## Access Compliance Report Public Rights-of-Way (Curb Ramps)

Intersection ID: 11663 Main Street: PARKWOOD\_AV Cross Street: PARSON\_ST Location: NW

ADA ID: E7F2ABAFD32E Ramp Type: Perp Initial Pass/Fail: Fail Overall Compliance: No Severity Score: 33.75

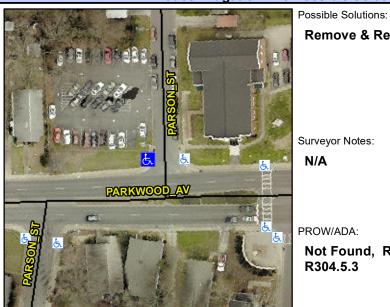
1 OSSIDIC OCIULIOTIS.				
Remove & Replace Entire Ramp.				
Surveyor Notes:				
N/A				
1071				
PROW/ADA:				
Not Found, R304.5.1, R304.2.2,				
R304.5.3

Field Measurements/Component Compliance							
Comp	liance Description	Data	Comp	liance Description	Data		
N/A	Ramp Length (in)	55.0	No	Ramp Slope (%)	8.5		
No	Ramp Width (in)	47.0	No	No Ramp XSlope (%)			
N/A	Flare Type LT	N/A	N/A	N/A Flare Type RT			
N/A	Flare Slope LT (%)	N/A	N/A	Flare Slope RT (%)	N/A		
N/A	Flare Traversable LT?	N/A	N/A	Flare Traversable RT?	N/A		
N/A	Landing Length (in)	N/A	N/A	DWS Provided?	N/A		
N/A	Landing Width (in)	N/A	N/A	DWS Contrast?	N/A		
N/A	Landing Slope (%)	N/A	N/A	DWS Length (in)	N/A		
N/A	Landing X Slope (%)	N/A	N/A	DWS Full Width?	N/A		
N/A	Landing Curb? (Y/N)	N/A	N/A	DWS Offset (in)	N/A		
N/A	Shared Landing?	N/A					
N/A	Gutter Ponding?	N/A	N/A	Gutter Slope (%)	N/A		
N/A	Gutter Lip Ht (in)	0.5	N/A	Gutter X Slope (%)	N/A		
N/A	Painted X Walk1?	No	N/A	N/A Painted X Walk2?			
	X Walk 1 Direction	To E		X Walk 2 Direction			
N/A	X Walk 1 Width (in)	N/A	N/A	X Walk 2 Width (in)	N/A
